DEVELOPMENT APPLICATION ASSESSMENT REPORT

Application Number:	DA2024/1276
----------------------------	-------------

Responsible Officer:	Stephanie Gelder
Land to be developed (Address):	Lot 31 DP 228119, 293 Hudson Parade CLAREVILLE NSW 2107
Proposed Development:	Alterations and additions to a dwelling house
Zoning:	C4 Environmental Living
Development Permissible:	Yes
Existing Use Rights:	No
Consent Authority:	Northern Beaches Council
Land and Environment Court Action:	No
Applicant:	ARCLab Pty Ltd

Figure 1. Section 3 (red highlighting height variation above 8.5m)

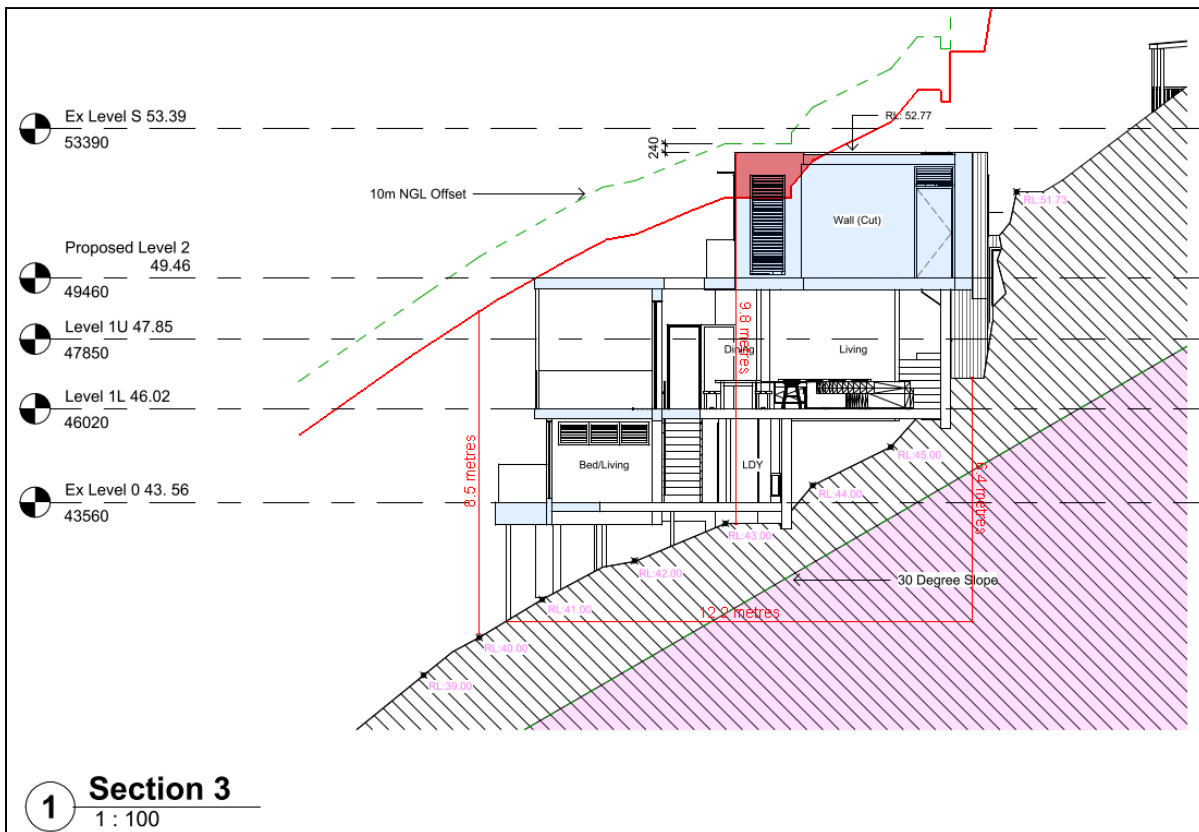
The proposed development presents a height of 9.8m (see Figure 1). The proposed height variation is resultant due to the steep sloping topography of the site, and highly constrained site due to a large existing rock outcrop and right of carriageway that is located through the middle of the site.

As detailed in Figure 1, the portion of the building above 8.5m is minor and constitutes the upper section of the proposed Level 2 and associated roof form. It is considered that the elements that are above the 8.5m height plane are minor areas, with the remainder of the development located below the 8.5m height of buildings development standard.

Figure 2. North West Elevation (red highlighting building envelope numerical non-compliance)

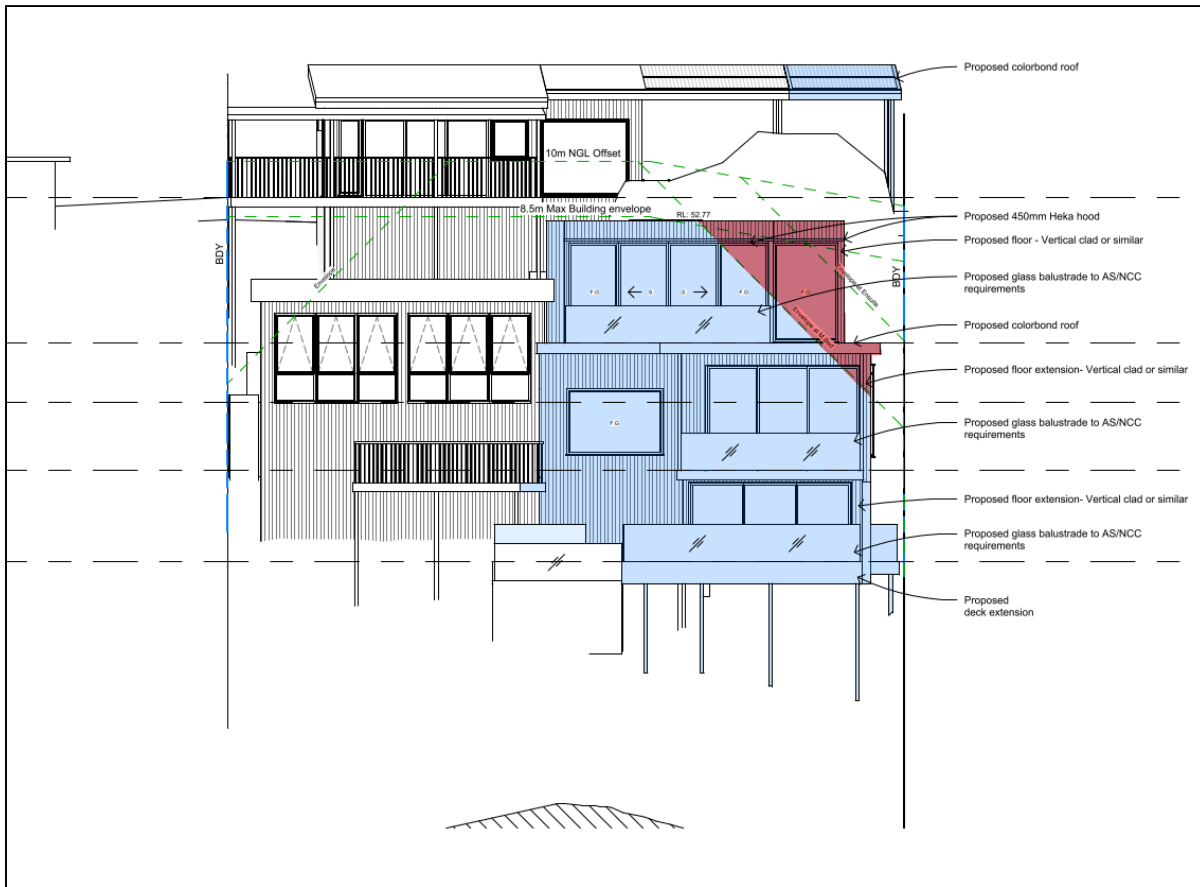
Under Clause D3.9 Building envelope of Pittwater 21 Development Control Plan, the building envelope control outlines buildings are to be sited within planes projected at 45 degrees from a height of 3.5 metres above ground level (existing) at the side boundaries. The proposal is within the envelope along the north-western elevation.

Figure 3. South West Elevation (red highlighting building envelope numerical non-compliance)

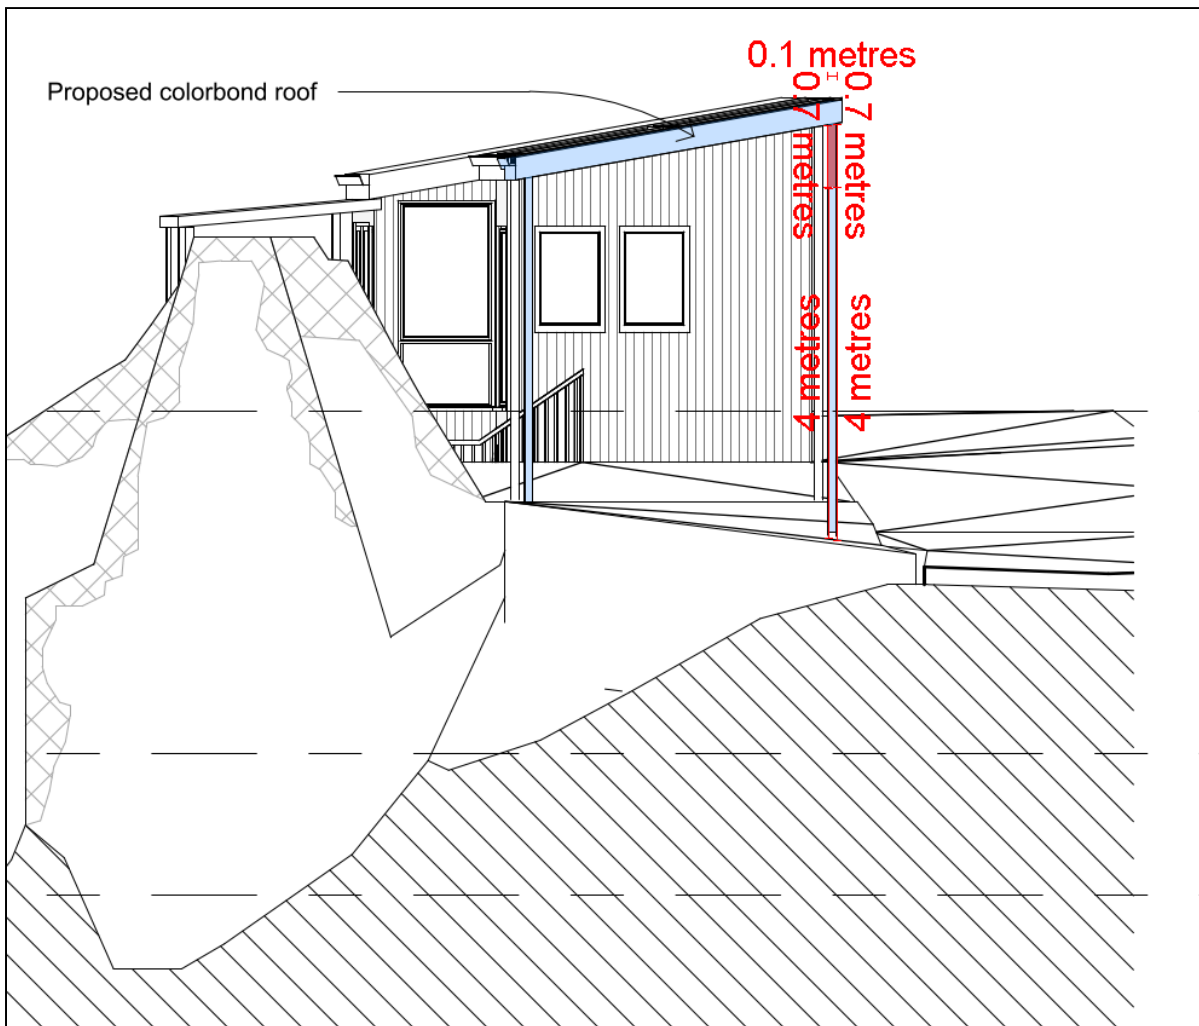
The proposal presents a building envelope breach along the south-west side elevation of the dwelling house. The south-west elevation is outside of the building envelope with a maximum vertical height of 4.4m and horizontal length of 5.0m, presenting in a maximum variation of 86.27% as outlined in Figure 2. The proposal presents a minor building envelope variation along the south-western side of the carport as a result of one of the carport posts. The south-west carport elevation is outside of the building envelope with a maximum vertical height of 0.7m and horizontal length of 0.1m, presenting a variation of 17.5% as outlined in Figure 3.

The proposed ensuite on Level 2 is stepped in to provide suitable articulation to the master bedroom resulting in the ensuite presenting the main area of the numerical building envelope variation. It should be noted that this area is for a length of approximately 4.2m. The proposed variation to the building envelope control is considered acceptable in this circumstance as the site is heavily constrained by the large existing rock outcrop, and the right of carriageway that runs through the middle of the site. Furthermore, as detailed in Figure 2 the existing dwelling house is a split level design that limits the opportunity for the addition of floor area as the additional floor is not able to be centrally located above the existing Level 1. The site has the benefit that to the south-west is a unused battle-axe handle that belongs to No.295 Hudson Parade. The dwelling house for No.295 Hudson Parade is located to the south of the subject site and it is noted that the battle-axe handle is limited to dense vegetation. Therefore, the next adjoining site to the south-west is separated by the battle-axe handle that provides further physical separation.
